UNITED STATES PATENT AND TRADEMARK OFFICE

| APPLICATION NO. | FILING DATE | FIRST NAMED INVENTOR | ATTORNEY DOCKET NO. | CONFIRMATION NO. |
|-----------------|-------------|----------------------|---------------------|------------------|
| 10/786,424 | 02/25/2004 | Kenneth S. Collins | 306 D13 | 2804 |

Office Action Summary

DETAILED ACTION

Fig. 2

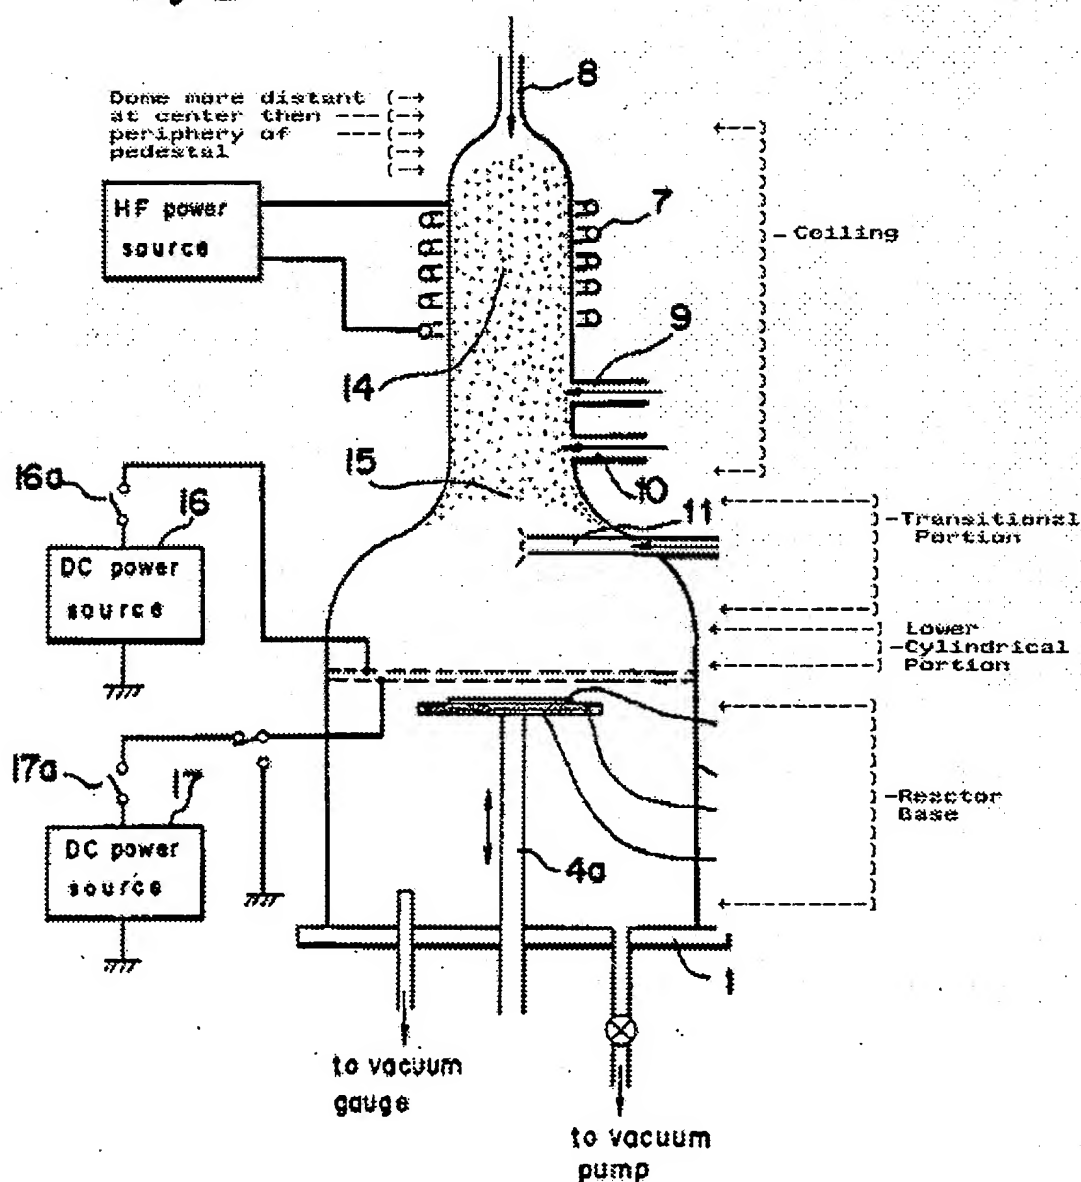
Regarding Claims 1, 2, 10, 11, 22, 23, 25 and 26, Hotomi teach in Fig. 2 a plasma chamber. (See Fig. 2) The plasma chamber includes a pedestal 4, which is adapted to hold a workpiece 3 to be processed. (Column 9 lines 65-68) A reactor base including base plate 1 houses the pedestal. (Column 9 lines 60-61; the reactor base includes the area between the grid and the base plate 1.) A high-frequency coil 7 is arranged adjacent the reactor and inductively couples power into the reactor. (Column 10 lines 11-17) The plasma chamber enclosure structure includes a bell jar 2. (Column 10 lines 60-64) The bell jar 2 is single walled. (See Fig. 2) The enclosure structure is inverted cup shape in

The plasma chamber enclosure structure covers the base. (See Figure 2) A plasma processing volume is 14, 15 defines a plasma-processing volume over the pedestal. (Column 11 lines 68; Column 12 lines 1-5) The plasma chamber enclosure is capable of transmitting inductive power through the enclosure from an antenna. (Column 10 lines 12-17)

The differences between Hotomi and the present claims are that the flattened conical configuration of the ceiling is not discussed, the plasma chamber enclosure structure being formed of a dielectric material of silicon, silicon carbide, quartz or alumina is not discussed and the flange portion extending radially outward from the side wall.
